# SUN CREST MEADOWS SUBDIVISION PHASE 1

## PROJECT NOTES

PROJECT NOTES FOR		SUN CREST MEADOWS SUBDIVISION PHASE 1	
Drawn By: MTH	Date: 07/17/18	Designed By:	Checked By:
Approved By:	Scale:	Approved By:	Scale:
Drawing File: 16-1051618(07-02-18)	JOB NUMBER: 16-105	Hansen & Associates, Inc. Consulting Engineers and Land Surveyors 538 North Main Street, Brigham, Utah 84302 Visit us at www.hai.com Logan Brigham City (801) 399-4905 (435) 752-8272	
SUN CREST MEADOWS SUBDIVISION PHASE 1		2550 NORTH 4900 WEST TAYLOR, UT 84401	
Sheet		1	
of		12	
Sheets

**2550 SOUTH ROAD SECTION**  
LOOKING WEST  
NOT TO SCALE

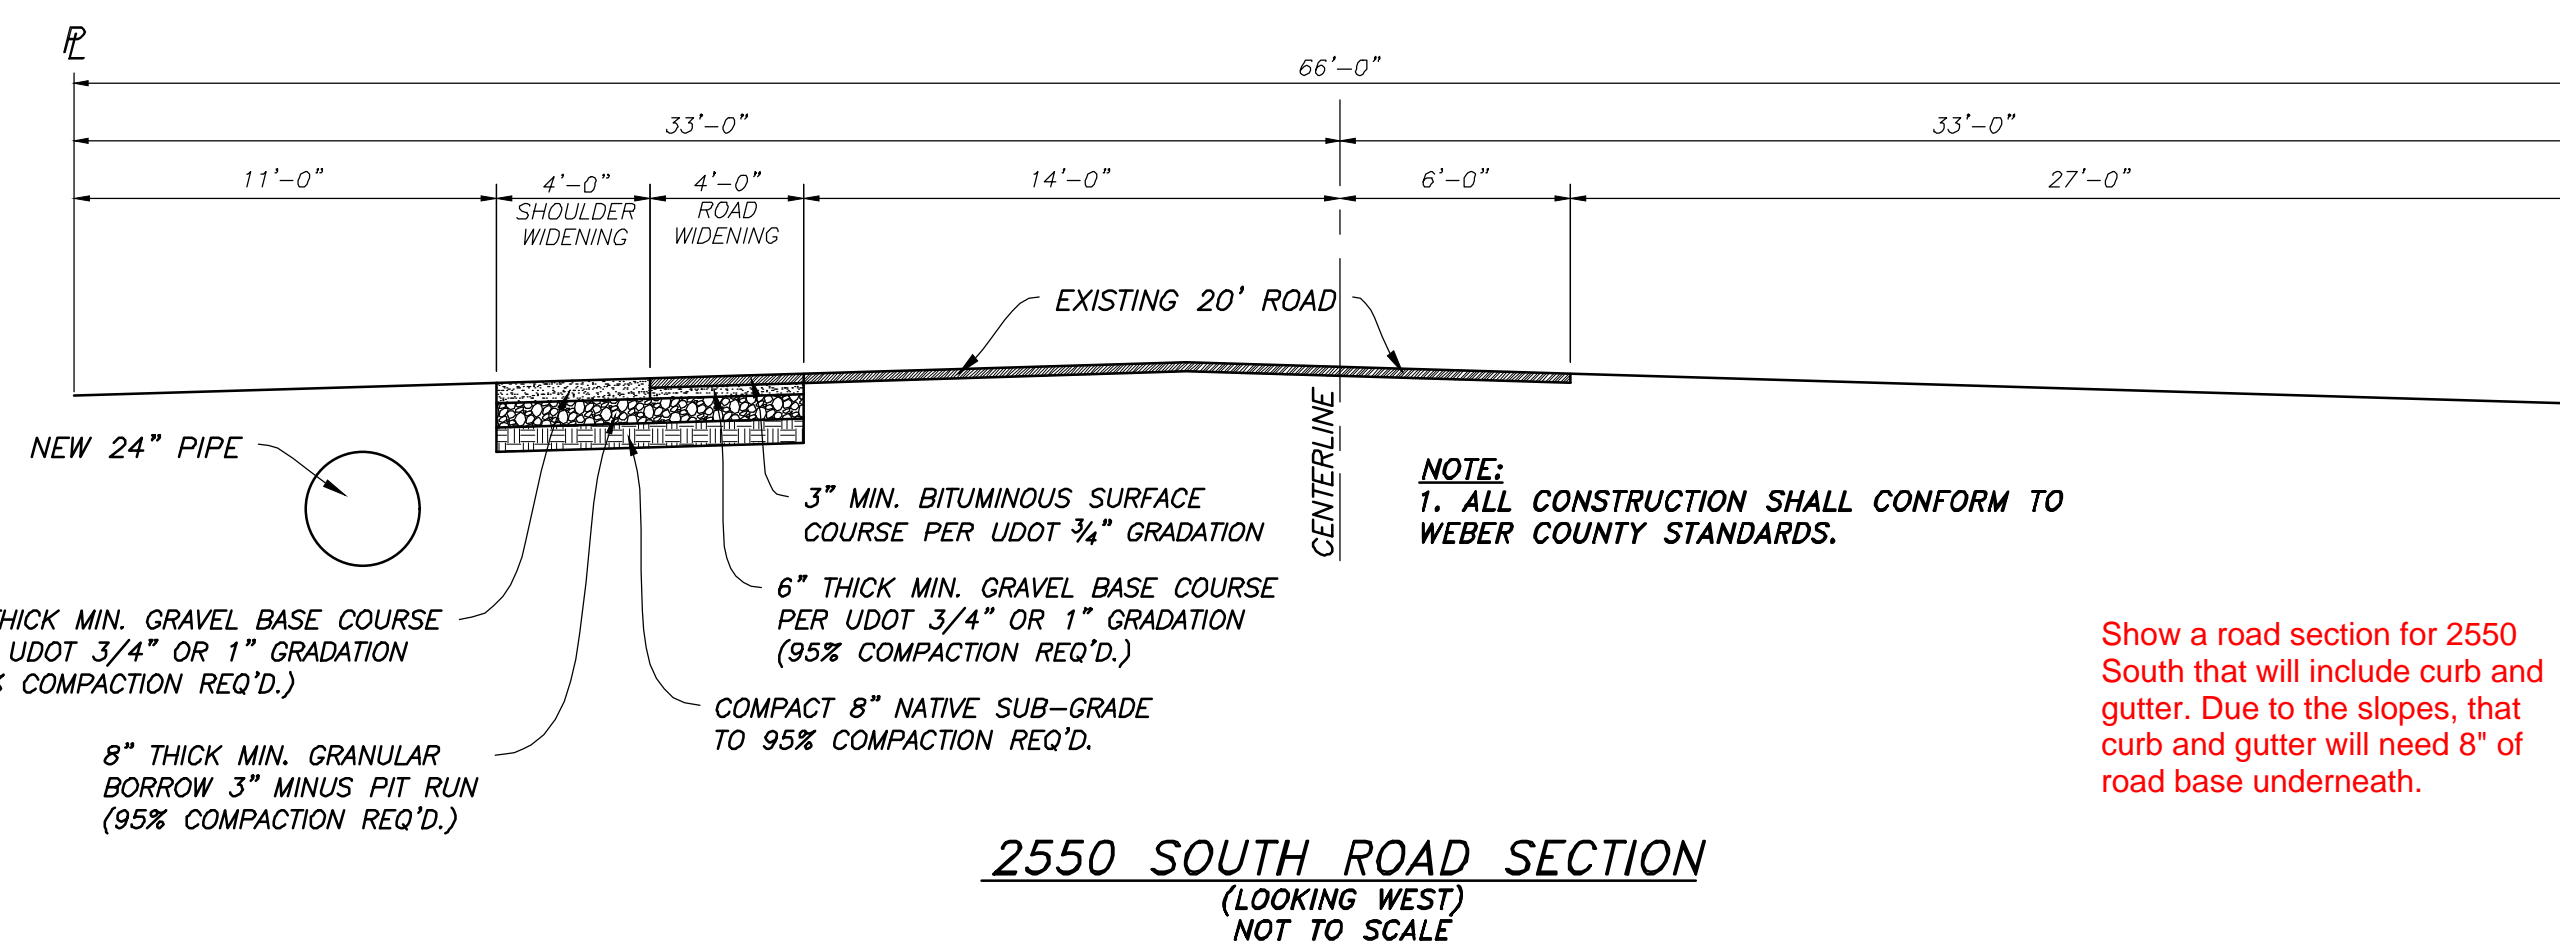
Show a road section for 2550 South that will include curb and gutter. Due to the slopes, that curb and gutter will need 8" of road base underneath.

SWPPP

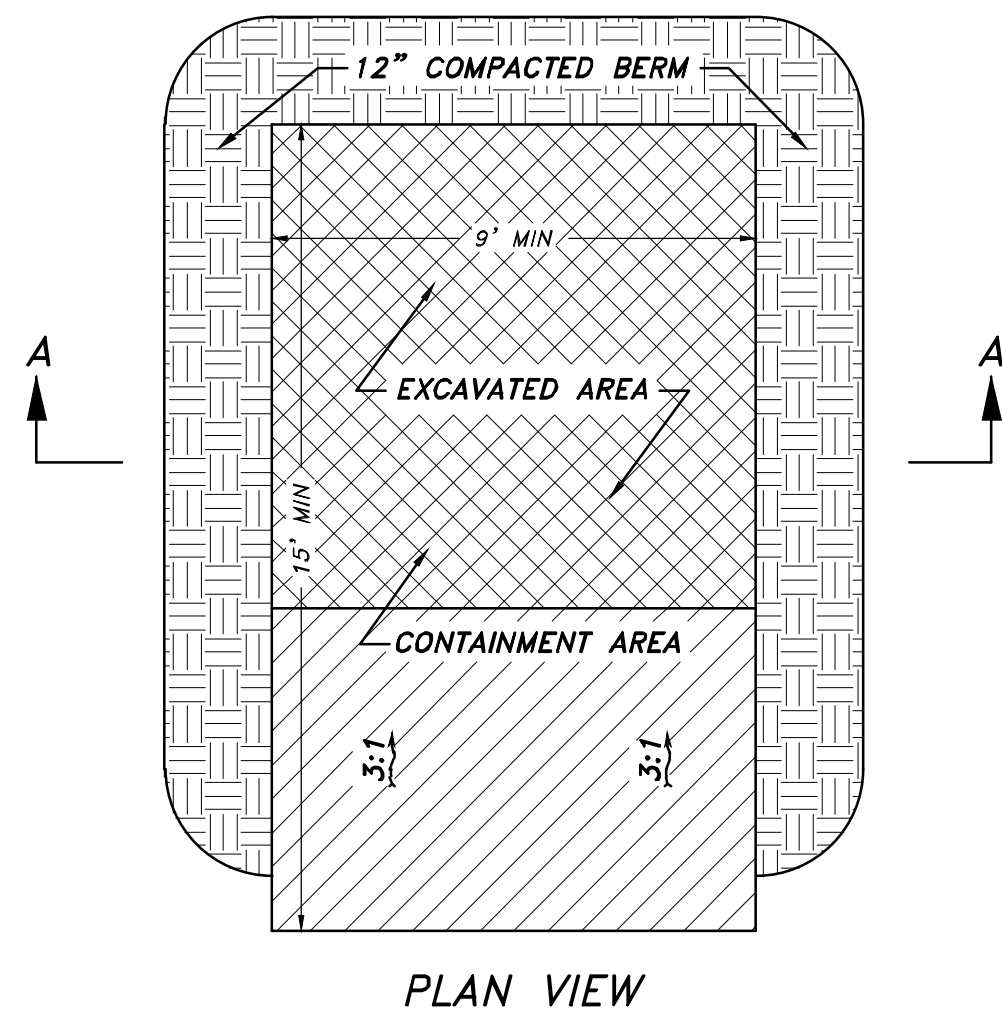
INSTALL ADDITIONAL FENCING AS NECESSARY TO DISTINGUISH WHERE THE ONLY ACCESS TO THE SUBDIVISION WILL BE AND DISCOURAGE ENTERING AND EXITING AT MULTIPLE POINTS.
